Mississippi Mills 2024-03-26
Issued for Permit

Owner/Applicant DCR/PHOENIX HOMES Telephone # 723-9227 Plan # 27M-47 Project nameWHITE TAIL RIDGE Civic Address:123 FRANK FISHER CR House model: BIRCHWOOD LOFT C	Bldg. Ht. 8.74 m Lot coverage 10 % Scale 1:250 Sod Area 1969 m ² Asphalt Area 87 m ²	<div><div><div>LOT 140</div><div>SITE/GRADING PLAN</div><div>WHITE TAIL RIDGE PH.IV</div></div></div>
	CHECKED/APPROVED BY: T.L.MAK ENG. REV. FEB.16/24 – CB

**Re: Proposed Single Family Dwelling, 123 Frank Fisher Crescent, Lot # 140 White Tail Ridge, Arnprior,
Kollaard Associates File # 240020**

With regard to structural issues only, Kollaard Associates has reviewed the following drawings:

GROUND FLOOR
ELEVATION C
1689 SQ FT

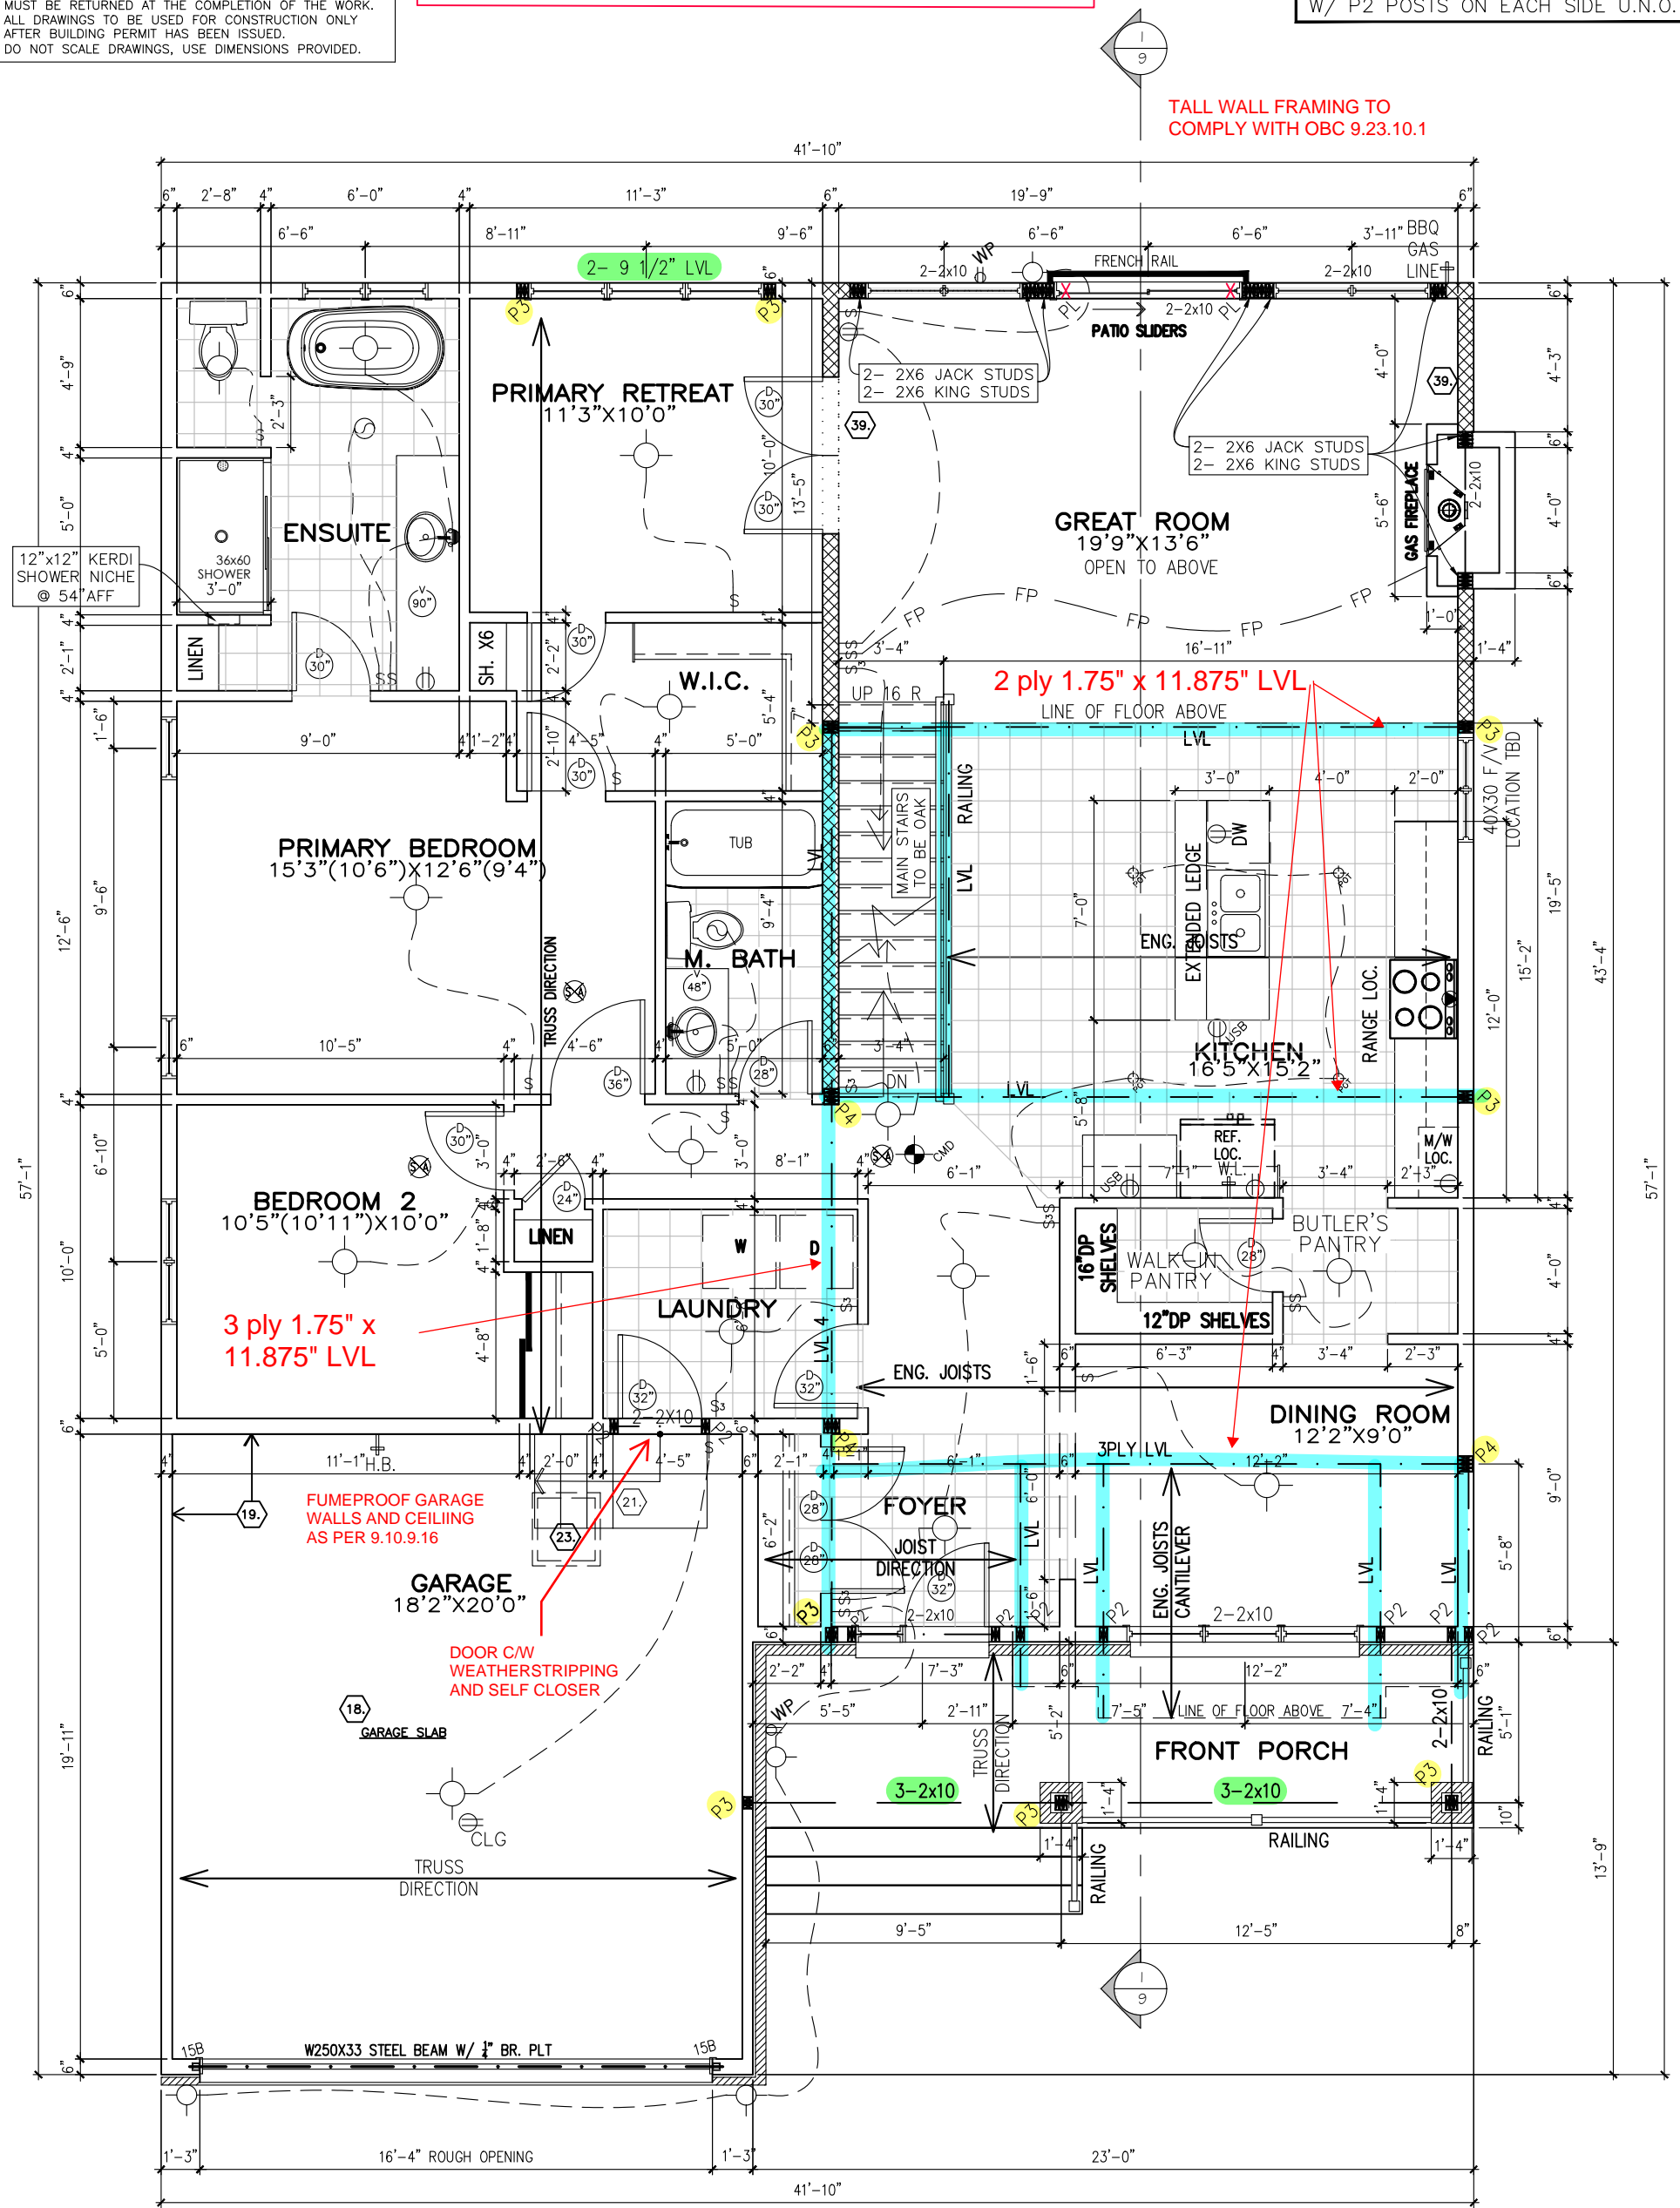
Ground Floor Plan – Pages # 3C:

4. It is the opinion of Kollaard Associates that the proposed lintels, beams and supporting posts shown on Phoenix Homes Sheets # 3C are adequate.
5. Ramset a 2x6 to the top flange of all steel beams to attach the above framing, floor joists and flush LVL beams.
6. Truss design is by others.

SECOND FLOOR PLAN
ELEVATION C
661 SQ FT

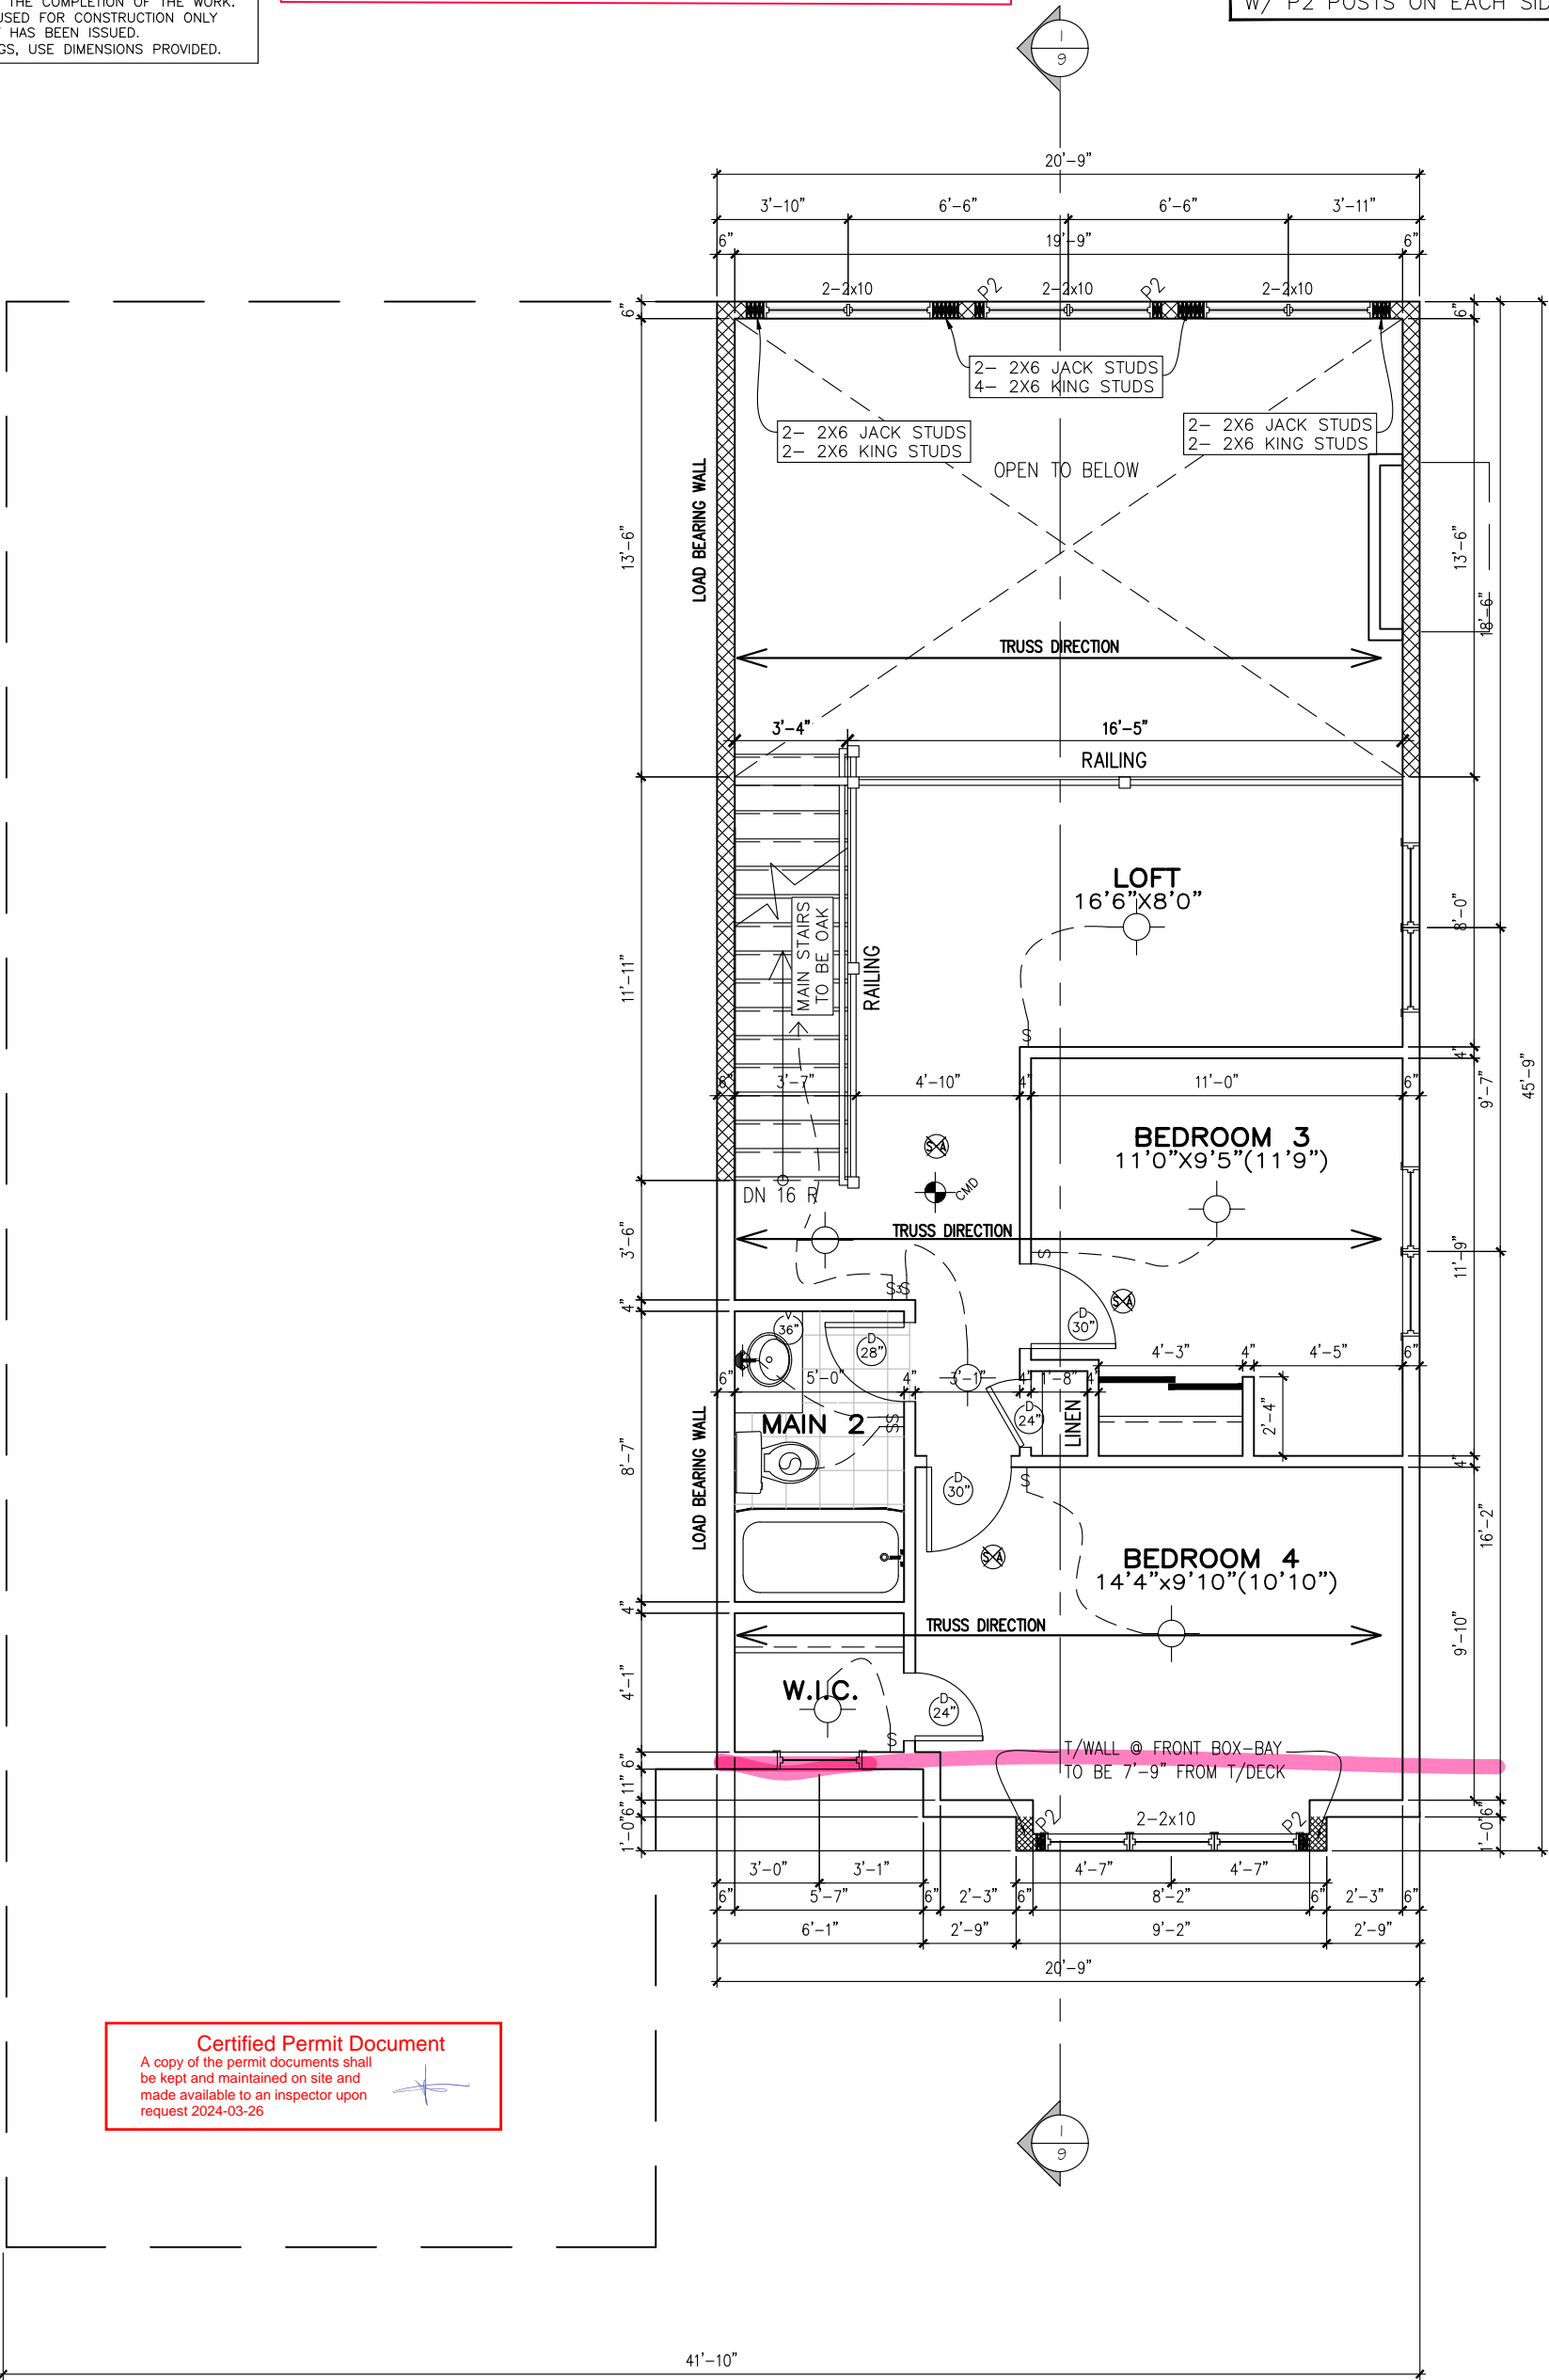
Second Floor Plan – Pages # 4C:

1. It is the opinion of Kollaard Associates that the proposed beams, lintels and built-up wood posts shown on Phoenix Homes Pages # 4C are adequate.
2. The proposed tall wall noted on Phoenix Homes Sheet # 1 is adequate.
3. Truss design is by others.

RIGHT SIDE ELEV C

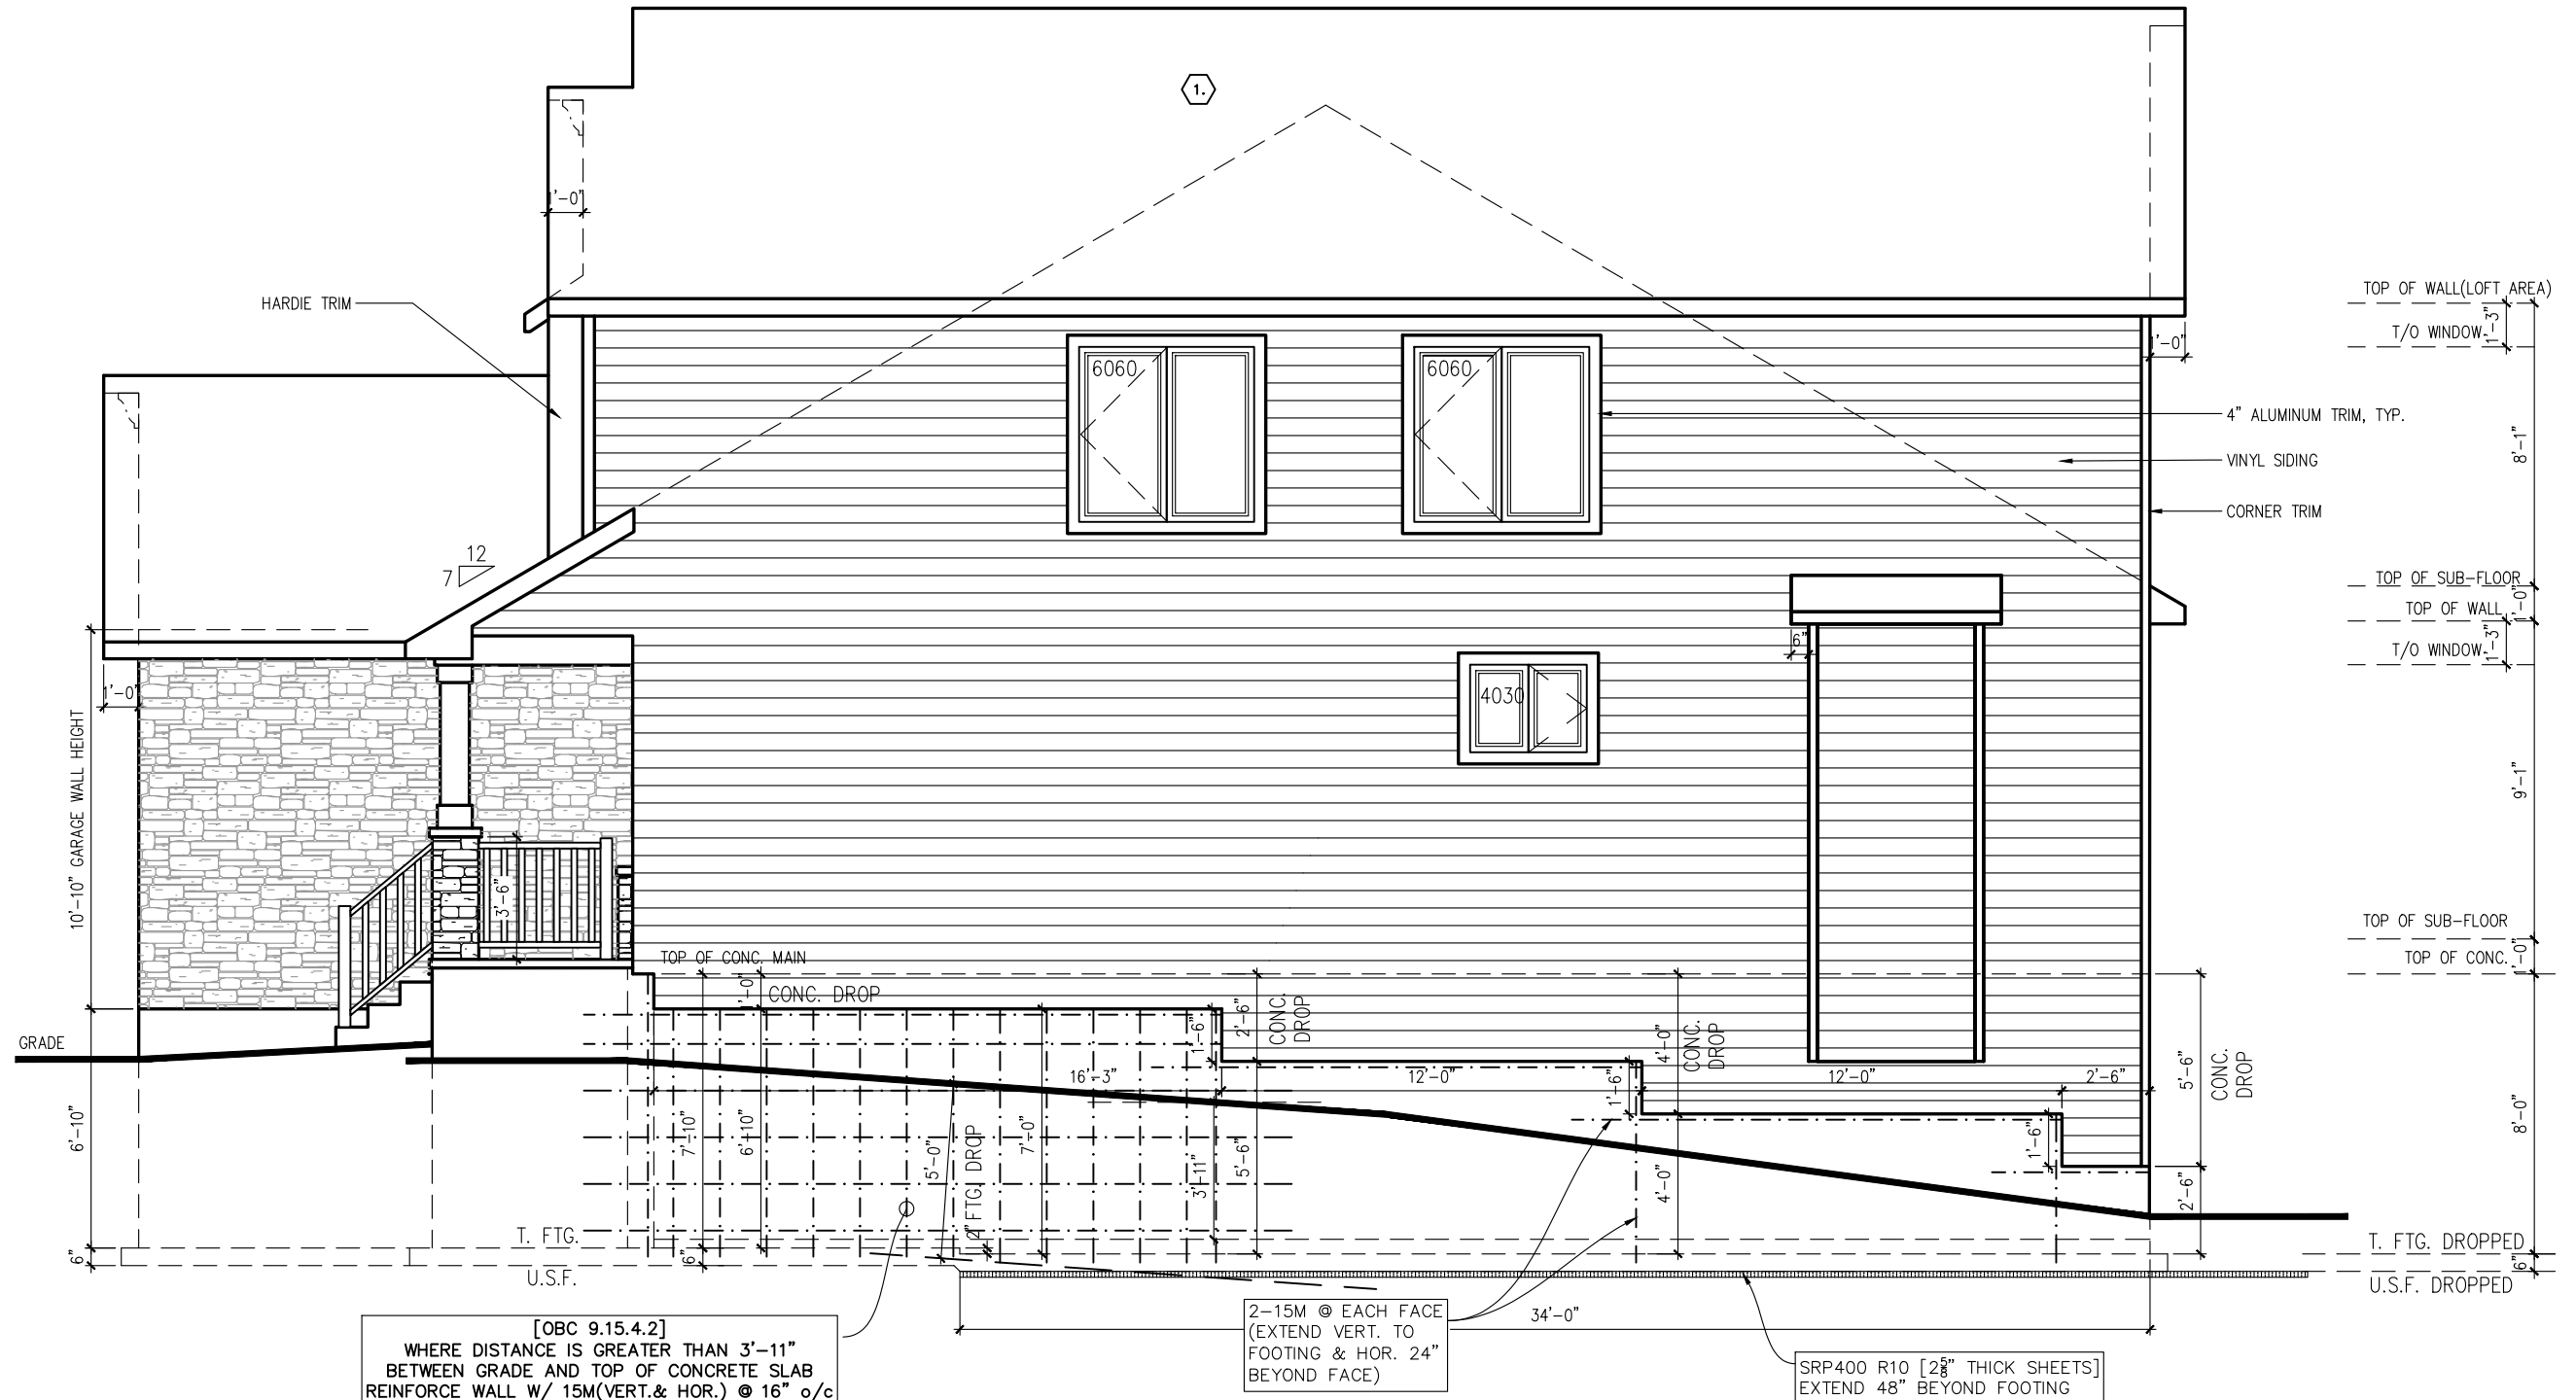
12. Where the grade difference between the basement slab and the exterior finished grade exceeds 3'-11" along the sides, the proposed foundation reinforcement noted on Phoenix Homes Pages # 6C and 7C are adequate to withstand the lateral earth pressures.
